**VIRGINIA ELECTRIC AND POWER COMPANY**  
**NORTH ANNA POWER STATION UNITS 1 AND 2**  
**PROPOSED LICENSE AMENDMENT REQUEST**  
**ADDITION OF ANALYTICAL METHODOLOGY TO THE CORE OPERATING LIMITS**  
**REPORT FOR A FULL SPECTRUM LOSS OF COOLANT ACCIDENT (FSLOCA)**  
**GAMMA ENERGY REDISTRIBUTION INFORMATION**

**GAMMA ENERGY REDISTRIBUTION INFORMATION**  
**FOR 10/30/19**  
**FSLOCA LAR SUBMITTAL**

**Virginia Electric and Power Company  
(Dominion Energy Virginia)  
North Anna Power Station Units 1 and 2**

Figure 1: North Anna Units 1 and 2 Peak Cladding Temperature for all Rods for the Region II Analysis PCT Case Assuming LOOP

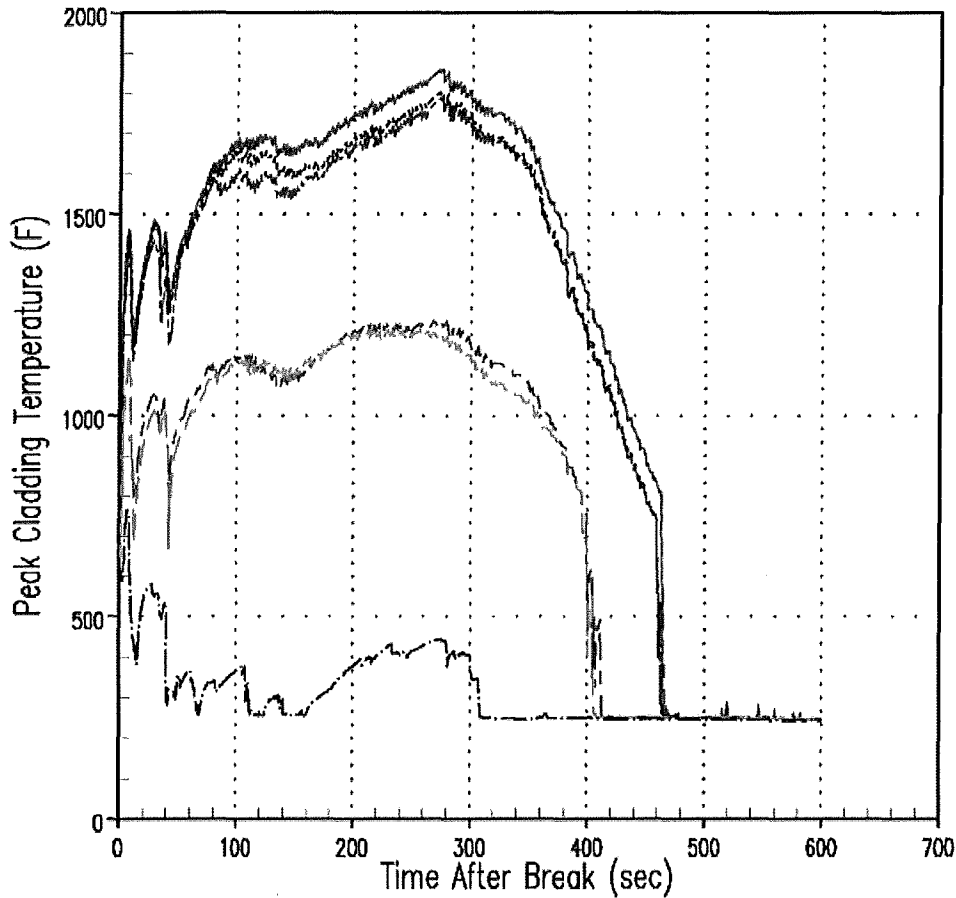
**Note: This figure presents the uncertainty analysis results without the PCT penalty for the gamma energy redistribution error correction**
